Reviewer: Amar Gajjam

Following are my comments on Set1.1 Fin plate shear connection.

## Comments on Set1.1:

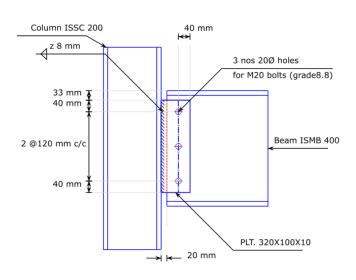
- 1. Not able to save (/save as) Osdag design file. This will enable us to open the same file, change some parameter and rerun.
- 2. From Error clause "Weld thickness is not sufficient [cl. 10.5.7; Insdag Detailing Manual, 2002]", it is not clear that "cl. 10.5.7" is from IS800 and the rest part is from Insdag manual. Also the particular clause reference shall be given from Insdag manual.

- 3. The weld size required is increasing with fin plate thickness. What we feel, the reference for weld size increase from Insdag is just guide line and not mandatory to increase the thickness if it passes for force.

- 4. In Column section, if we choose ISMC column, the graphics won't change.
- 5. There should be an option to enter the location of first top bolt from top flange .In current program the fin plate is entering in flange part of beam. It should start below the flange excluding radius of curvature. Also bolt are closer to curve part
